National Electrical Safety Code
Interpretations
1978—1980 inclusive

**ANSI/IEEE C2
Interpretations 1978-1980**

National Electrical Safety Code Committee, ANSI C2

Fig IR 282-1

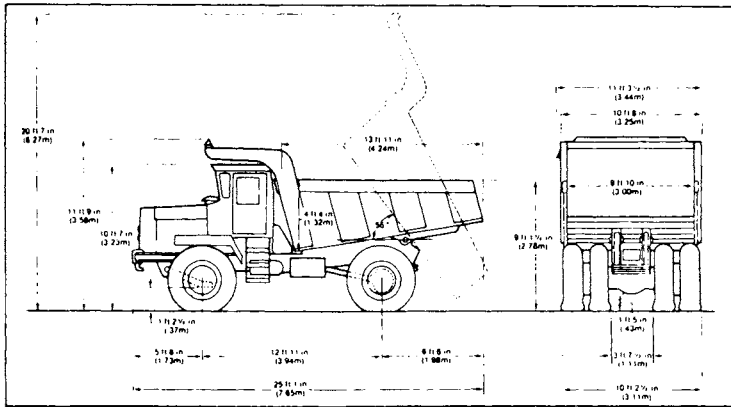
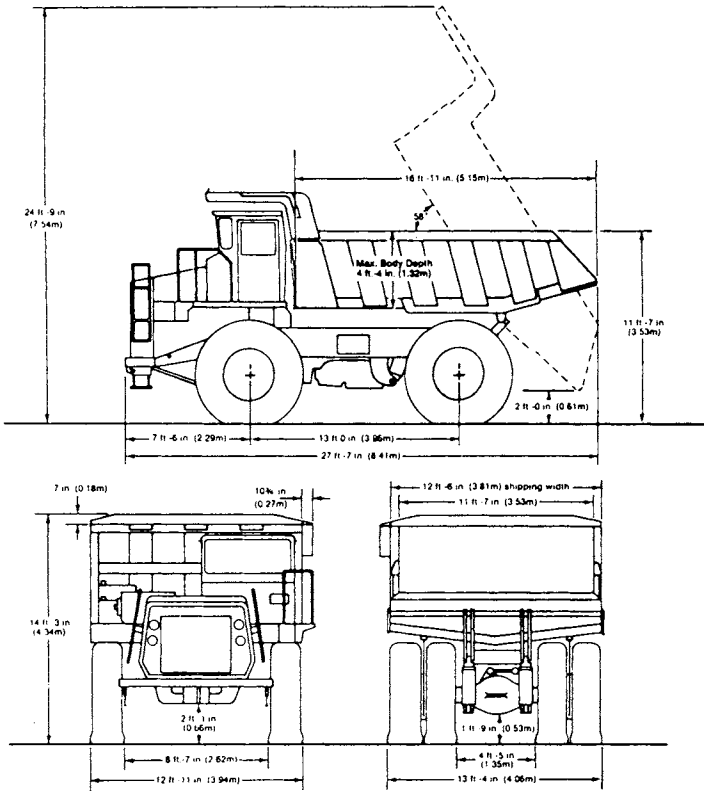
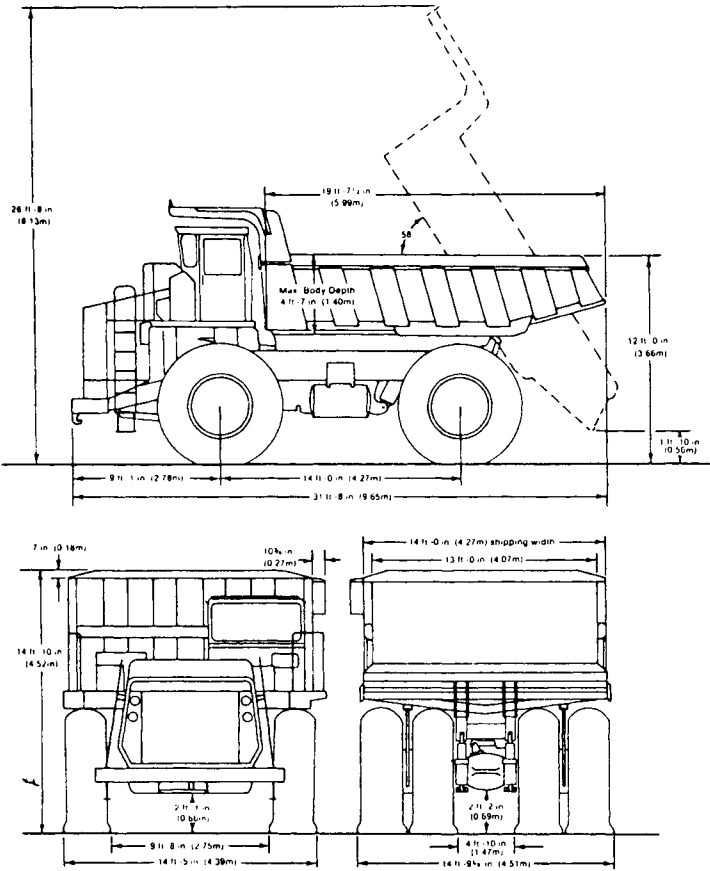
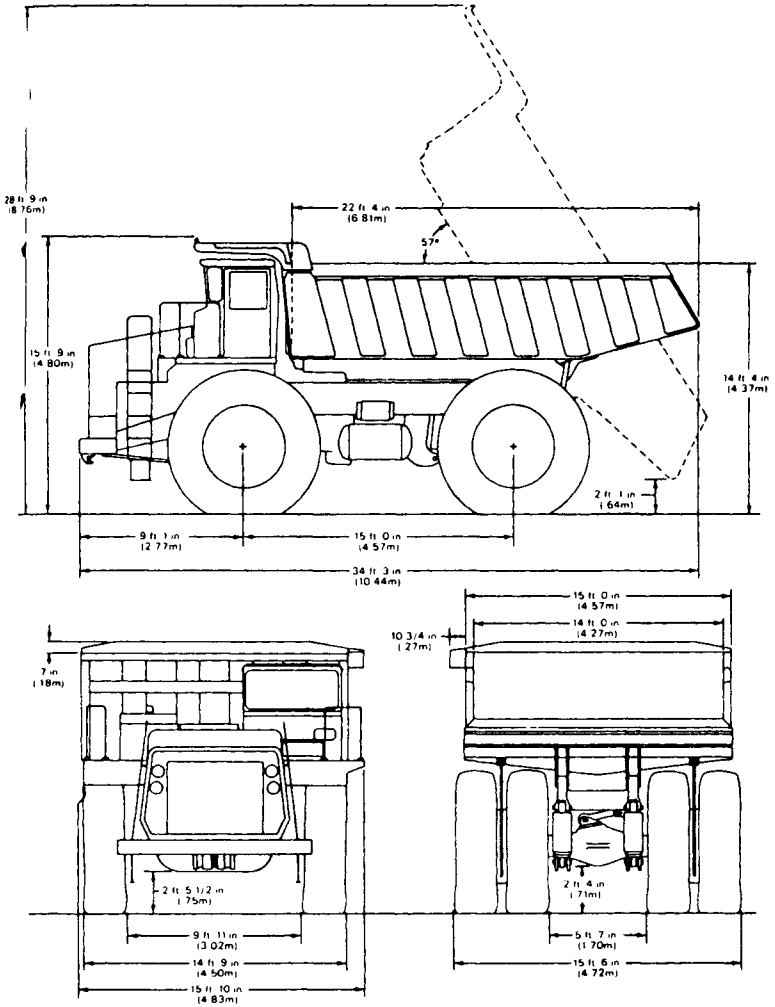
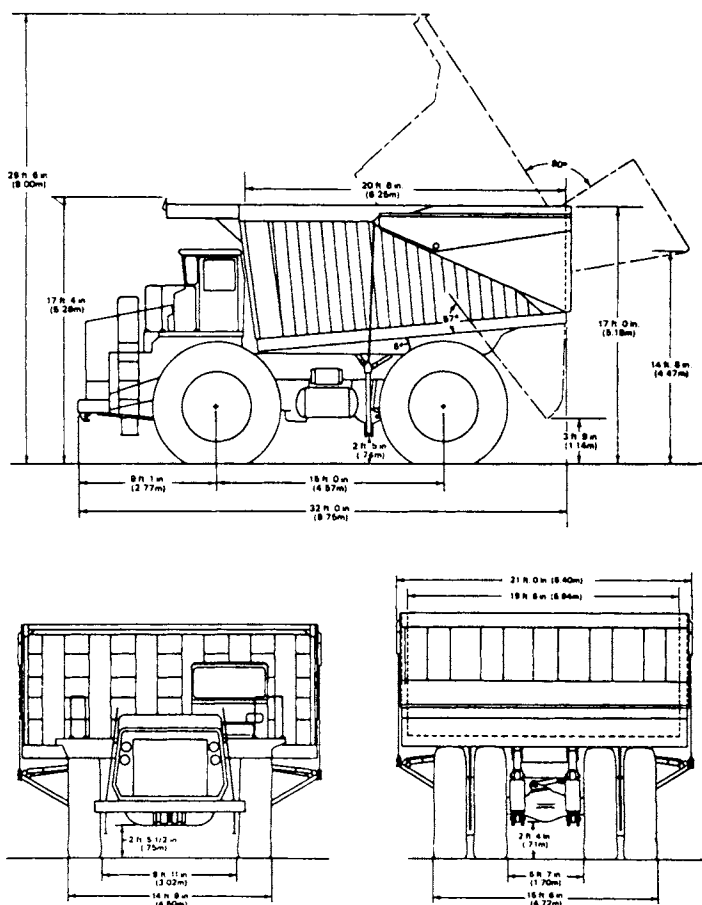
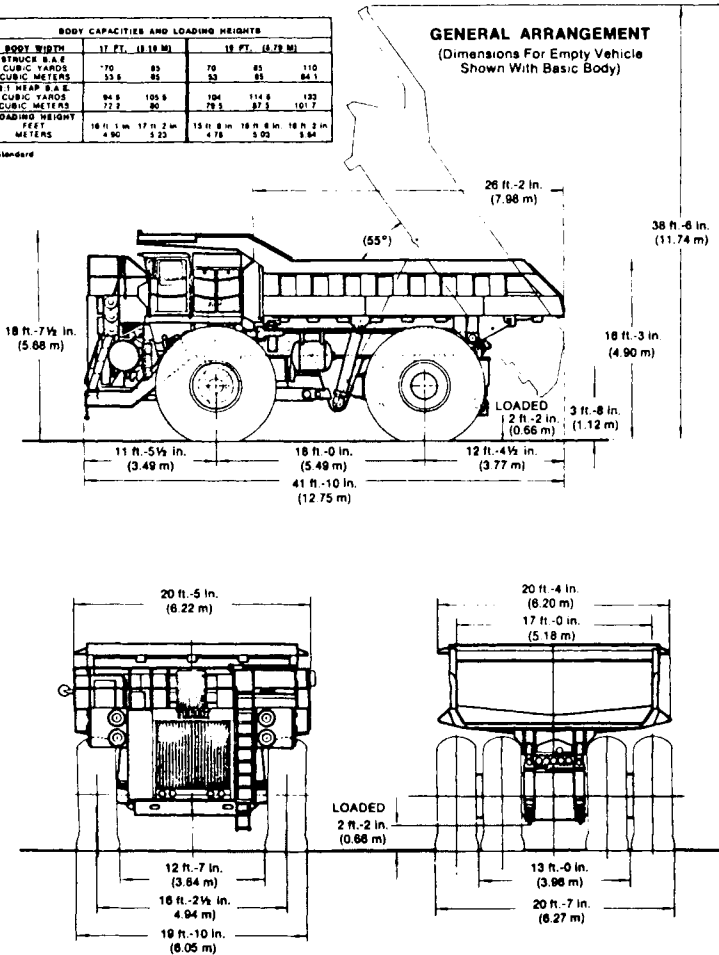
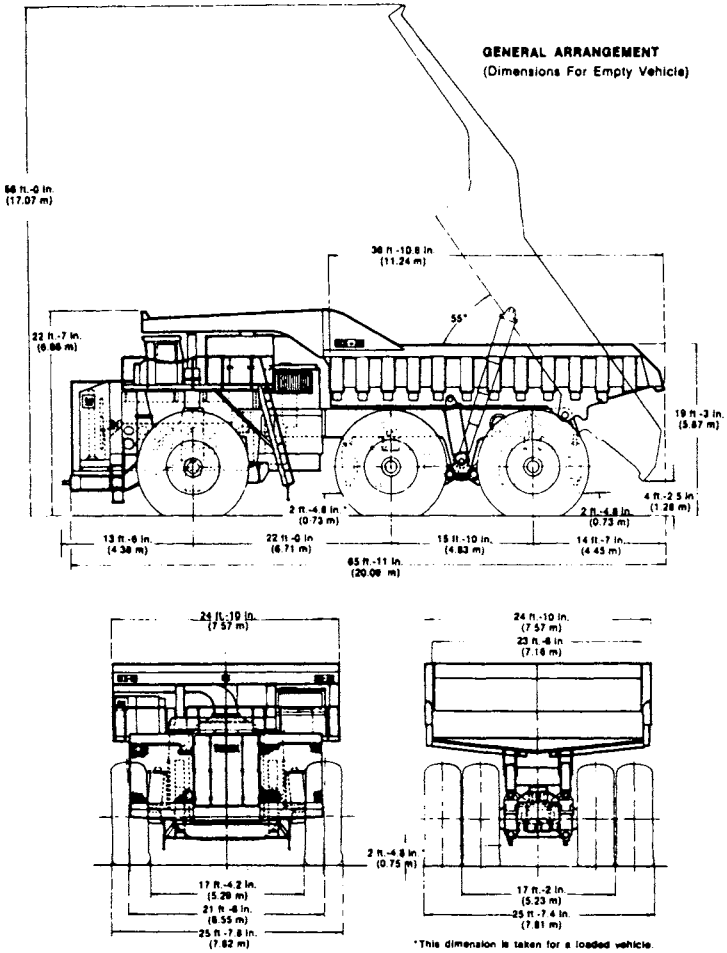
Another separate but related matter of concern is the height of power lines located in close proximity to truck dump sites. As an example, a dump point located approximately 100 ft from and parallel to power lines. The haulage trucks would back up passing under the power lines enroute to the dump point. Because of the nearness of the power lines, it is imperative that the dump body be fully lowered before any forward progress of the truck.

... question is, would ANSI recommend any additional clearance distance for power lines located in close proximity to sites where truck dump bodies are operated (see Figs IR 282-1-7 for vehicle height examples).

The Code does not specifically address the question of clearances where snow accumulation in the vicinity of supply lines may be significant. Rules 200, 210 and 211 do, however, provide some general requirements.

Fig IR 261-1

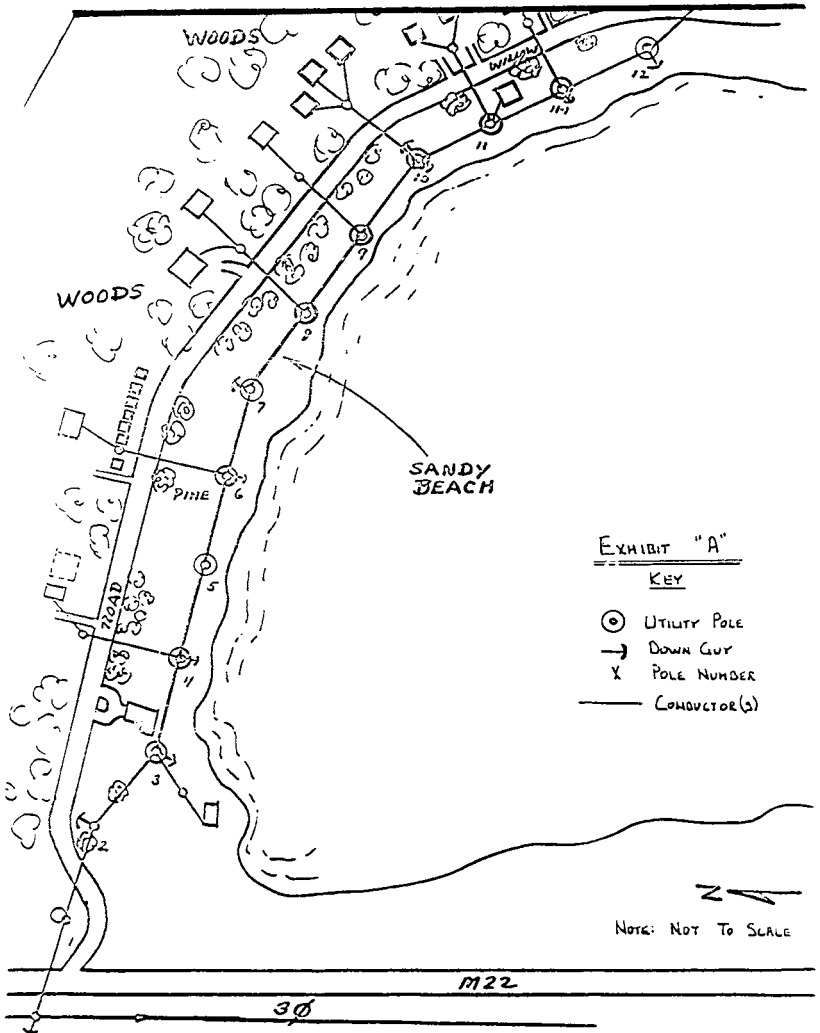
REA Bulletin 40-7, April 29, 1977, directs ... [the company] ... to comply to the National Electrical Safety Code. Our specific question is: Must this portion of distribution line (and similar ones) comply with Item 8 of Table 232-1?

In our view, the description of the land traversed by your line does not require the higher clearance specified by Item 8 of Table 232A. Further, Rule 202B2 makes it clear that installations which comply with prior editions of the code need not be modified to meet the requirements of the 1977 code.

Fig IR 269-1

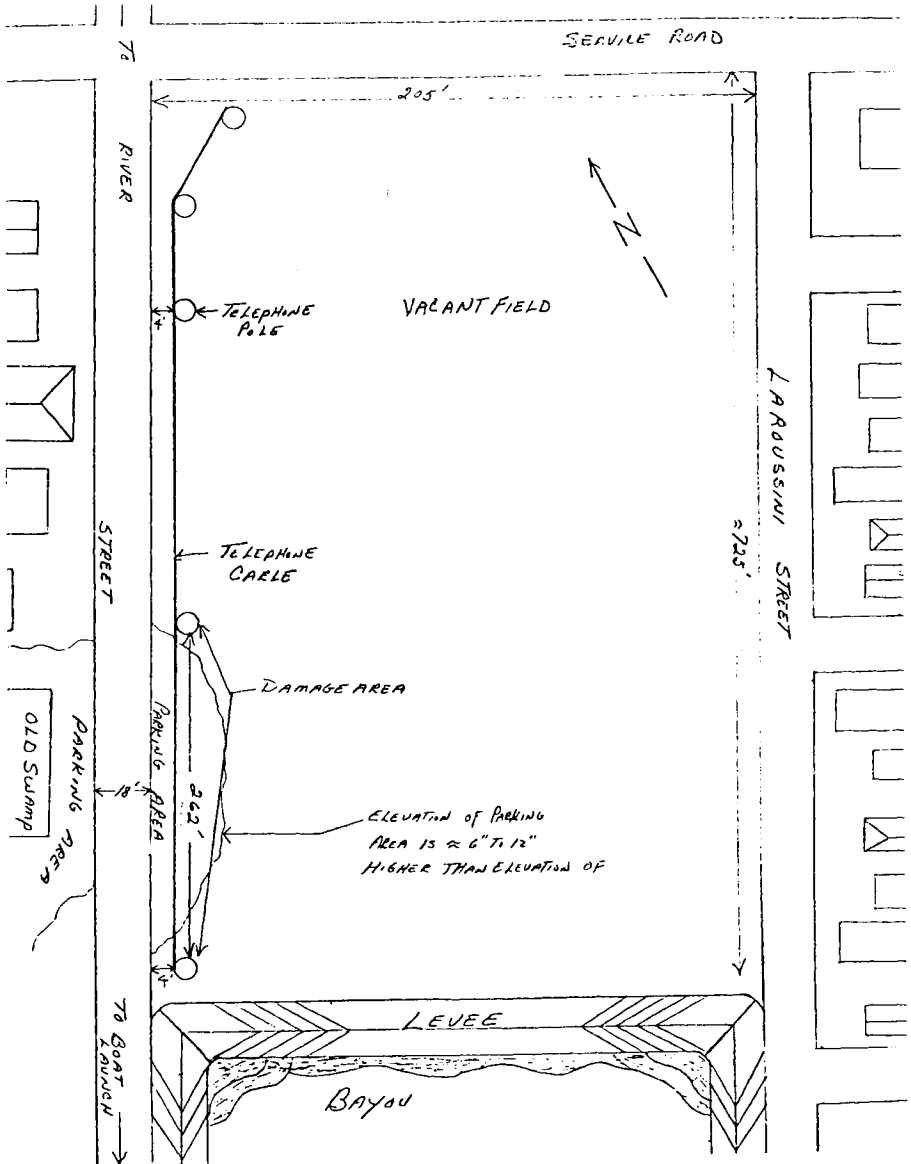
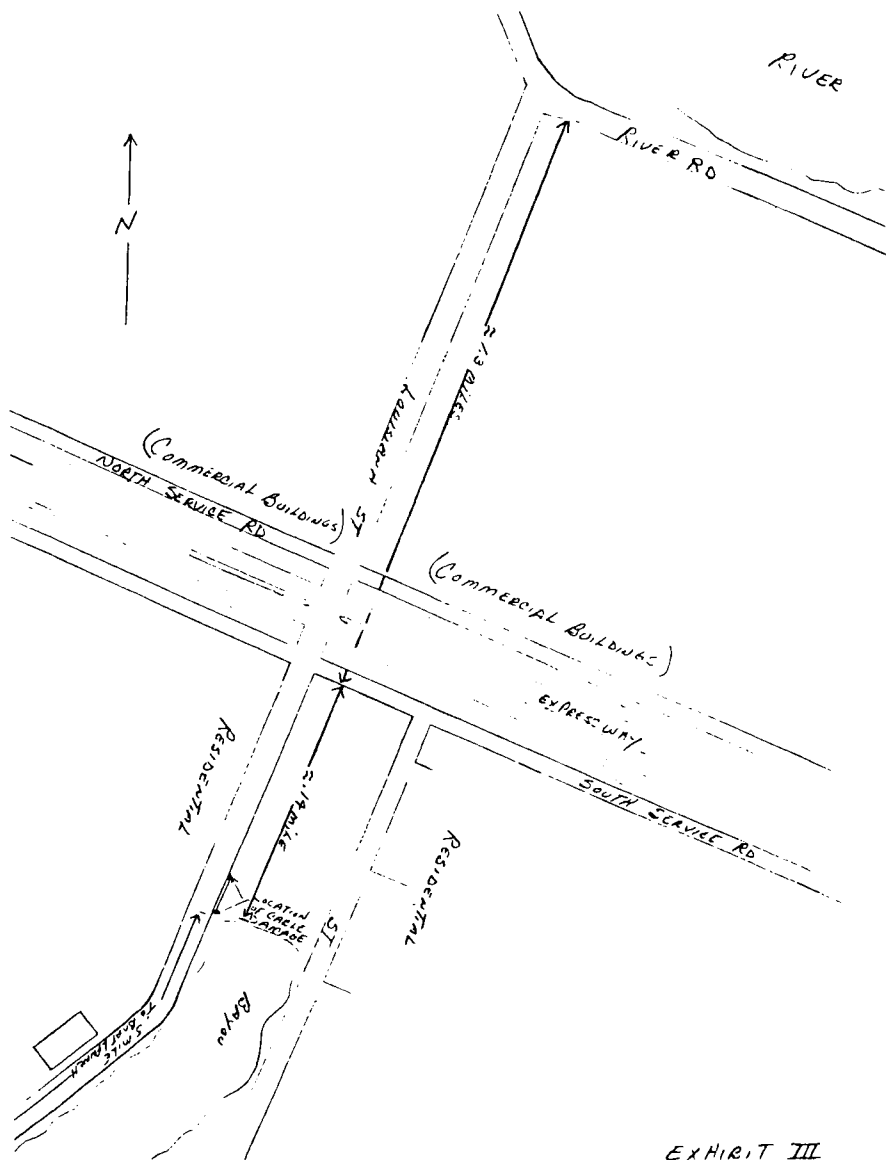
Number of vehicles towing boat trailers—8

Number of U-turns made in the area of the cable damage—3 (1 auto & 2 small trucks)

Based upon your description of the area and the traffic count accompanying it, the locale in question must be considered urban. The required 60°F clearance for the installation is 18 ft.
